**Re: Washington Street – Franklin Flex Space
Site Plan Peer Review**

On behalf of the applicant Franklin Flex Space, LLC., we have provided a summary of the following outstanding comments from BETA Group, Inc. dated December 15, 2021. Our responses are immediately following each comment and they have been italicized.

**Re: Washington Street (Franklin Flex Space)
Site Plan Peer Review Update**

BETA Group, Inc. has reviewed revised documents for the project entitled **Site Plan Washington Street** in Franklin, Massachusetts. This letter is provided to update findings, comments, and recommendations.

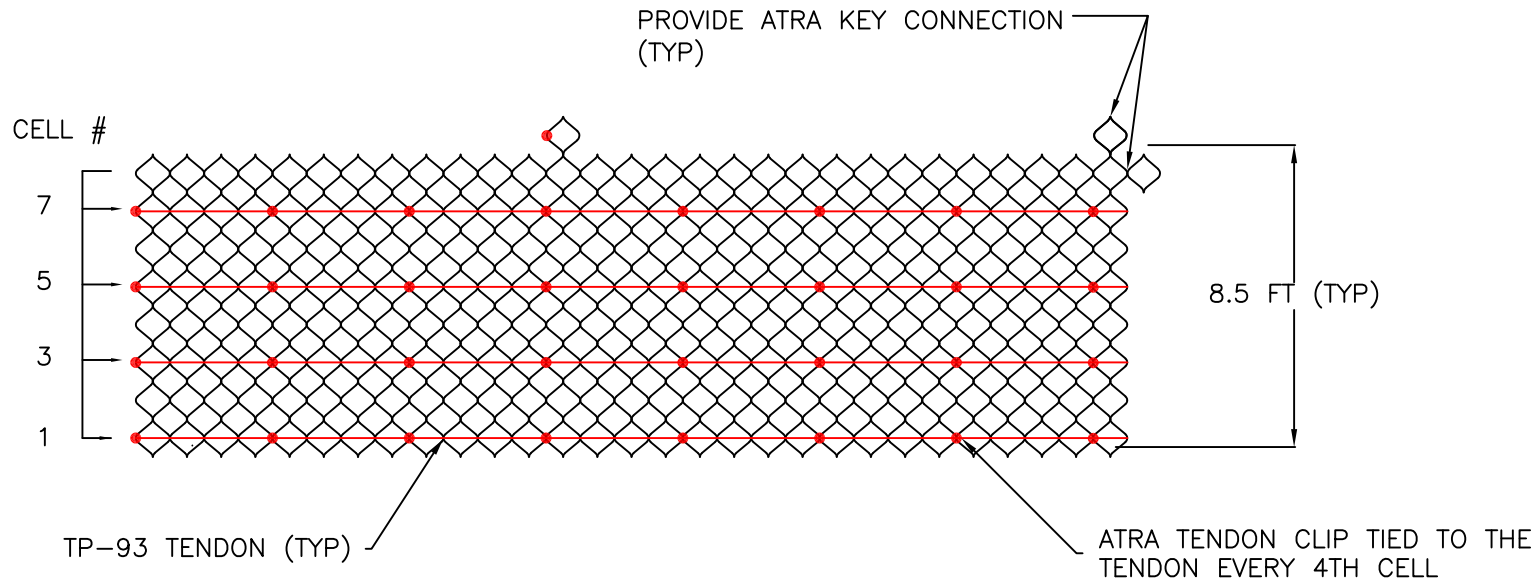
BETA2: As noted in the referenced documents, the provided design is for surface stability only and assumes that the underlying slope is stable against failure. If the Board elects to approve the project,

BETA recommends a condition of approval that requires slope stability to be evaluated by a geotechnical engineer and that a representative of Geoweb manufacturing is on site during construction to ensure the system is installed as designed.

BETA 3: Long term stabilization of the slope is the issue not constructability. They are proposing to install 2 rows of trees on the slope and all the runoff from the area between Washington Street and the slope will flow over this grade. The geotechnical report should be revised to address these specific long term maintenance issues.

UCI2: The applicant has engaged a geotechnical engineer to evaluate the soil conditions and to complete a slope design. The applicant is amenable to the recommended conditions or approval.
